APPLICATION NO.	FILING DATE	FIRST NAMED INVENTOR	ATTORNEY DOCKET NO.	CONFIRMATION NO.
10/648,038	08/26/2003	Alexander E. Andreev	03-0933/L13.12-0240	2425

Office Action Summary	Application No.	Applicant(s)	
	10/648,038	ANDREEV ET AL.	
	Examiner	Art Unit	
	Mujtaba K. Chaudry	2133

DETAILED ACTION

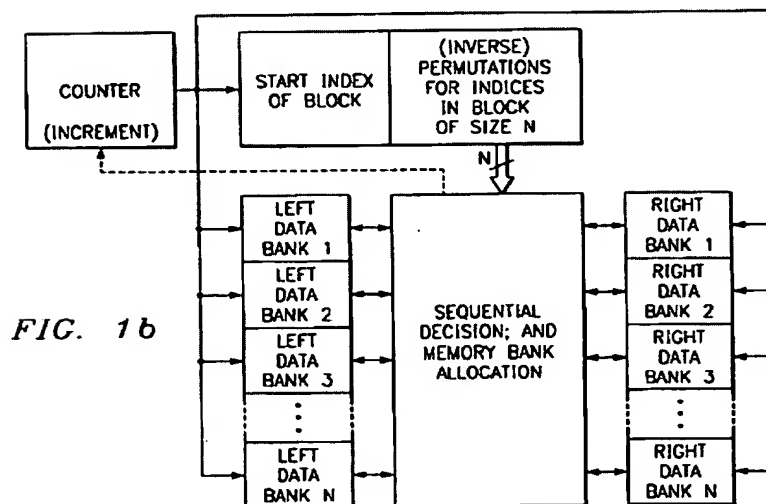
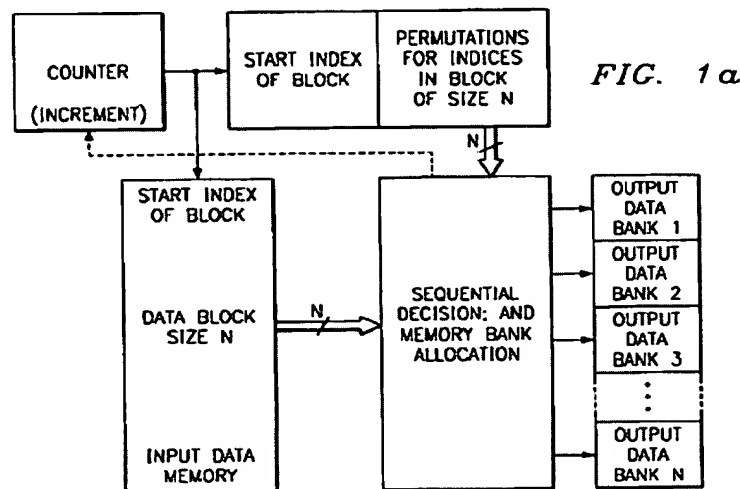
The drawings are objected to because:

- Figure 1 should be designated by a legend such as --Prior Art-- because only that which is old is illustrated. See MPEP § 608.02(g). Corrected drawings in compliance with 37 CFR 1.121(d) are required in reply to the Office action to avoid abandonment of the application. The replacement sheet(s) should be labeled "Replacement Sheet" in the page

- Figure 2 should be designated by a legend such as --Prior Art-- because only that which is old is illustrated. See MPEP § 608.02(g). Corrected drawings in compliance with 37 CFR 1.121(d) are required in reply to the Office action to avoid abandonment of the application. The replacement sheet(s) should be labeled "Replacement Sheet" in the page header (as per 37 CFR 1.84(c)) so as not to obstruct any portion of the drawing figures. If the changes are not accepted by the examiner, the applicant will be notified and informed of any required corrective action in the next Office action. The objection to the drawings will not be held in abeyance.
